**ANSWERS TO THE REFEREES FOR THE ARTICLE ENTITLED
“HYDROMETEOROLOGICAL EVALUATION OF TWO NOWCASTING SYSTEMS FOR
MEDITERRANEAN HEAVY PRECIPITATION EVENTS WITH OPERATIONAL CONSIDERATIONS.”
SUBMITTED TO HYDROLOGY AND EARTH SYSTEM SCIENCES**

POINT BY POINT ANSWERS TO REFEREE 1

Additional figure : 3-D representation of the weight α given to radar extrapolation in PIAF. It shows the PIAF forecast lead time (interval [0, 180 minutes]) dependency on α (interval [0, 1]) for PIAF forecasts starting from 12 October 2016 18:05UTC to 13 October 2016 00:05UTC.

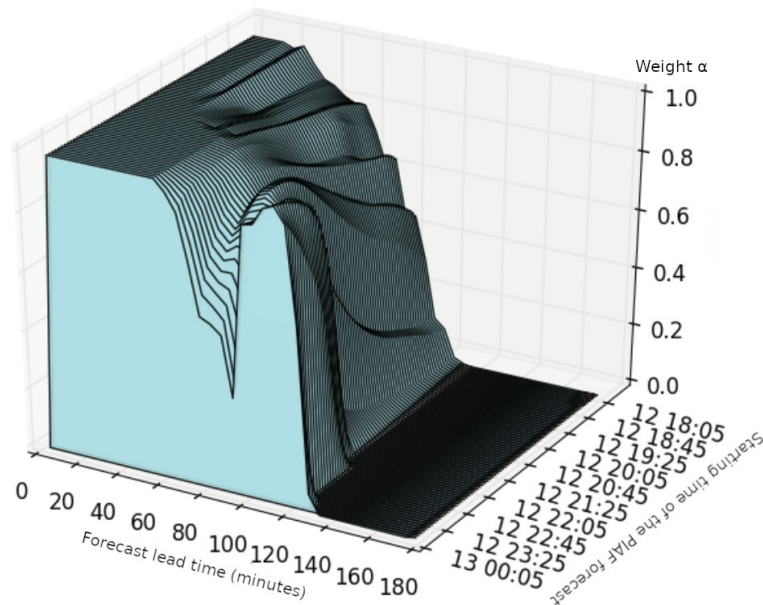
Section 2.2.2. I think the authors should be more detailed about PIAF, I see they cite another paper and a presentation (found on web) but this is an interesting part of the paper. They should insert more formalization about PIAF about the blending methods and some equations and if necessary a scheme, so that readers can understand how the system works. Currently the paragraph is too generic.

⇒ In the revised manuscript, we will expand this section by including more details about PIAF. The second paragraph will be modified and an additional figure will be added as follows:

“PIAF is based on a sequential aggregation of these two predictors (radar extrapolation and numerical prediction) and the results of blending is a linear compound of both of the form: $PIAF = \alpha * Extrapolation + (1-\alpha) * AROME-NWC$. Its aim is to perform better than the best predictor. The accuracy of a prediction proposed by the experts (radar extrapolation and AROME-NWC) or by PIAF is measured through a loss function. The Gerrity score (Gerrity Jr, 1992) described in Appendix A is here used to estimate the loss of each product with respect to the radar quantitative precipitation estimates. The difference between the forecaster’s accumulated loss and that of an expert is called regret, as it measures how much the forecaster regrets, in hindsight, of not having followed the advice of this particular expert (Cesa-Bianchi and Lugosi 2006). As the forecaster’s goal is to minimize the regret, the weights given to each predictor in PIAF are adjusted according to their deviation from the previous 6 hours observations, this results in weighting more the expert whose cumulative loss is small. The polynomially weighted average forecaster with multiple learning rates (ML-Poly, Cesa-Bianchi and Lugosi 2006, Gaillard and Goude, 2015) is the aggregation rule used in PIAF to assign weights to each predictor. This method provides a real choice of predictor rather than a mixture. The weights depend also on the forecast range (additional Figure) and on the geographical area, according to a division of France into six sub-areas. PIAF is run every 5 minutes with a 3 hours lead time and a time step of 5 minutes. Forecasts are available within 2 minutes.”

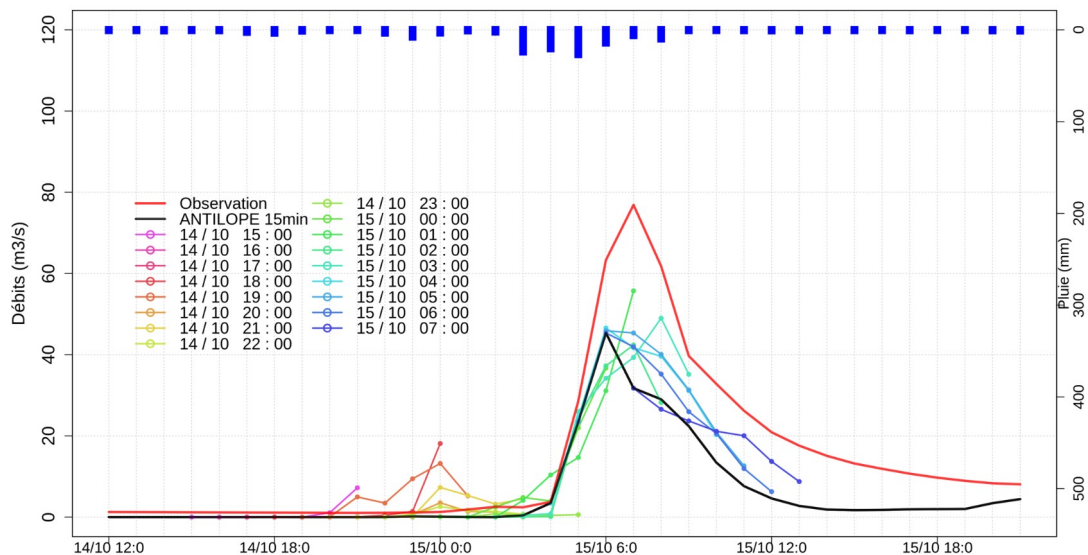
Table 4: outlet Pépieux, it is not clear to me if the sequence 6/3/4 is possible. But again

⇒ You are right, there was a typing error, the correct sequence is 6/3/3.

“6” for the forecasts starting at 19UTC, 21UTC, 02UTC, 03UTC, 04UTC and 05UTC (Figure 3 hereafter). “3” for the forecasts starting at 02UTC, 04UTC and 05UTC.
